Preliminary Flood Impact Report – Proposal for new Crown Cemetery in Lidcombe

October 2025

Figure 3: Flood map showing flood waters in and around the subject site (Cumberland City Council, 2025)

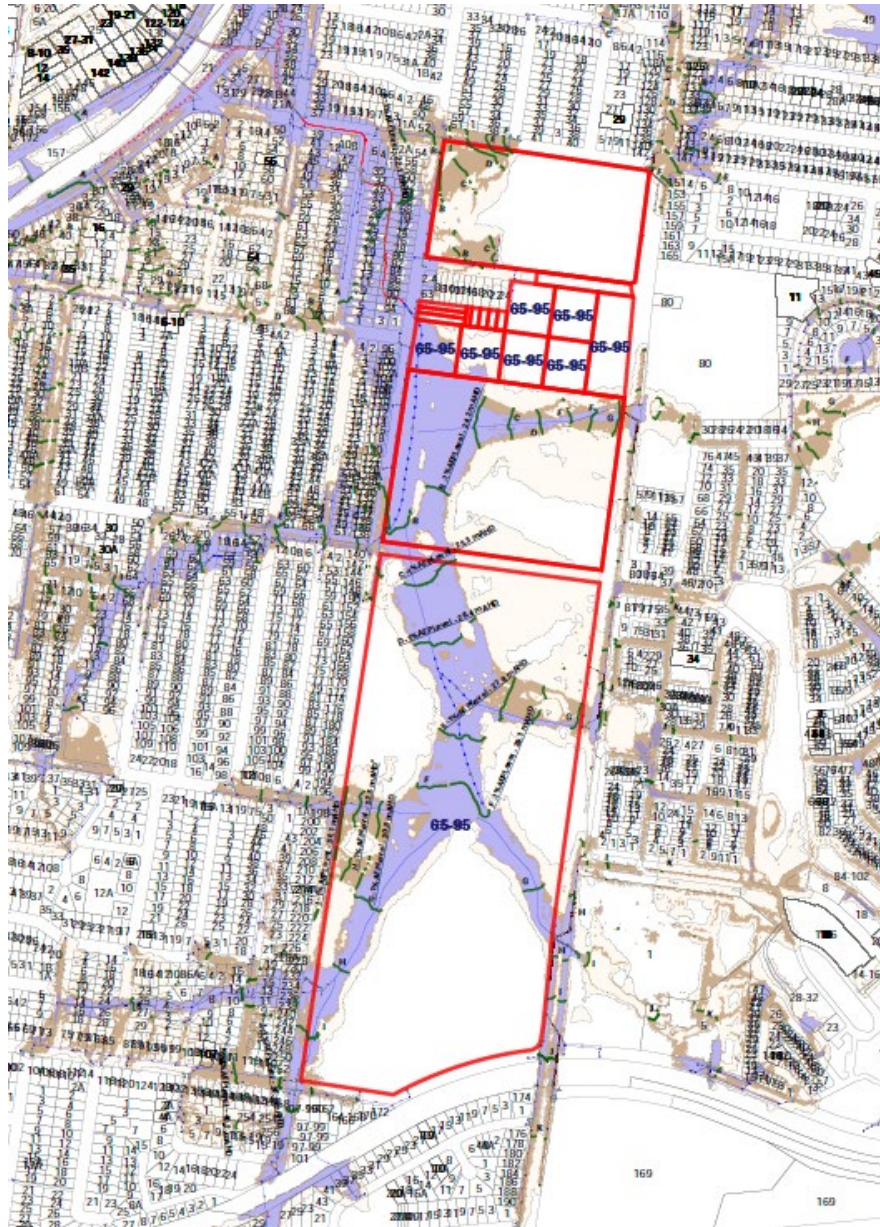
The purple shaded area in Figure 3 represents areas where flooding is expected to occur. The brown shaded area in Figure 3 represents the flood waters with a depth of flow less than 100mm and does not attract any flood controls. It is presented on the flood map to show the continuity of flooding within the area. However, if development occurs within the brown areas, the structure shall not impede or divert flows to adjacent properties.

The effects of flooding events impacting a cemetery site has the potential to have detrimental planning and environmental impacts. Flood impact assessments must be required to ensure that burial sites are located above the flood planning level and incorporate resilient design features. Proper drainage, elevated burial platforms, and emergency access routes are essential to mitigate flood risks and protect public health, water quality, and long-term site stability if this proposal is pursued.

It is recommended that future flood modelling (pre and post development flood study) be calibrated to Council's 1% AEP Flood levels (or interpolated levels) at least 10 metres upstream and downstream from the property boundaries.

Council's TUFLOW model for the catchment is available and recommended to be used to undertake the assessment. Once engaged, the consultant must enter into a license agreement for the use of Council's flood model for the specific purpose of preparing the FIA for the proposed development. In cases where uses of the TUFLOW model proves impractical, using an alternative 2D model is advised for the FIA preparation.
